To: INCITS Technical Committee T10
From: Kevin Butt
Date: December 18, 2006 3:17 pm
Document: T10/06-462r1 — SSC-3: Keyless Copy

4.19.13 Keyless copy of encrypted data

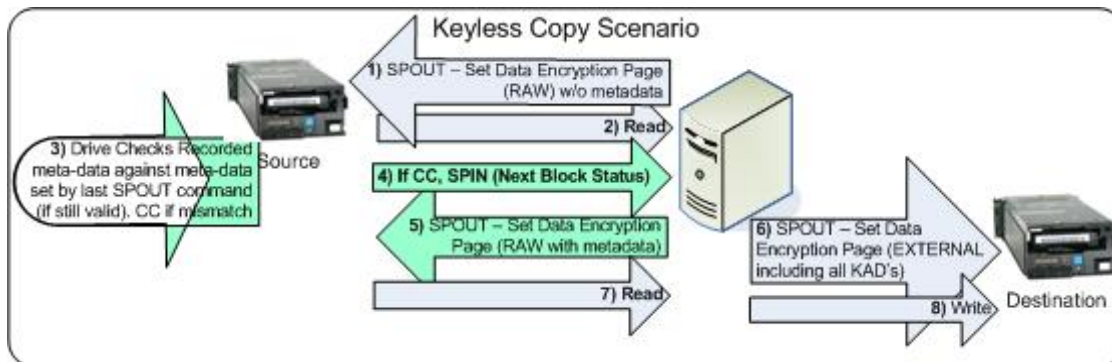
To describe the proposed solution I will use a picture and description of each step here and then the proposal portion will attempt to capture the necessary modifications/additions to make it work.

1. The application sends a SPOUT command setting the decryption mode to RAW. No KAD descriptors are sent.
2. The application begins reading.
3. The drive checks to see if any KAD descriptors are required for a successful RAW read to EXTERNAL write. If yes (the format requires KAD descriptors sent), then the drive returns a CC with the sense key set to DATA PROTECT, and the additional sense code set to INCORRECT DATA ENCRYPTION KEY. If no (the format contains all data within the block), the drive returns the read data and skips to step 6.
4. The application sends a SPIN command requesting Next Block Status. This would potentially include KAD descriptor 0x03.

5. The application sends a SPOUT command setting the decryption mode RAW and the KAD descriptors to the KAD descriptors returned in step 4. Since the data manager is required to set the KAD descriptors (if there are any), there is an explicit action required.
6. The application sends a SPOUT command setting the encryption mode to EXTERNAL and, if step 4 was required, all the KAD descriptors returned in step 4.
7. The application reads data until finished or the next CC. If a CC is returned for incorrect data encryption key then go to step 4.
8. The application writes the data read (either in step 7 or step 2).
